South King Fire and Rescue
Station 61 Facility Improvements

ADDENDUM #2
May 5, 2017

The Bid Documents issued **March 16, 2017** for the project noted above are amended by this Addendum.

MSK-1

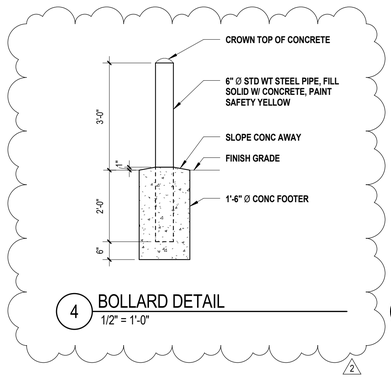
ADD: Package ERV with core.

REPLACE: energy wheel
WITH: energy core

1. Pre-Bid Walkthrough Sign-In Sheet (2 pages).
2. Substitution requests (4 pages).
3. Revised Sheet A10.01.
4. MSK-1.
   - a. Heat exchanger type: Core,
   - b. No Microprocessor control required.

ENERGY RECOVERY VENTILATOR SCHEDULE

MARK	MAKE	MODEL	TYPE	SUPPLY			EXHAUST			HEAT EXCHANGER		ELECTRICAL				WGT.	NOTES
				CFM	ESP	HP	CFM	ESP	HP	MATERIAL	WINTER EFF.	MCA	MOCP	VOLT/PH	SCCR	LBS	
ERV-1	GREENHECK	ECV-10-VG	ROOFTOP	650	0.75	1/2	675	0.75	1/2	CORE	68.5%	7.2	10	208/1	NOTE A	500	ALL
										1					1
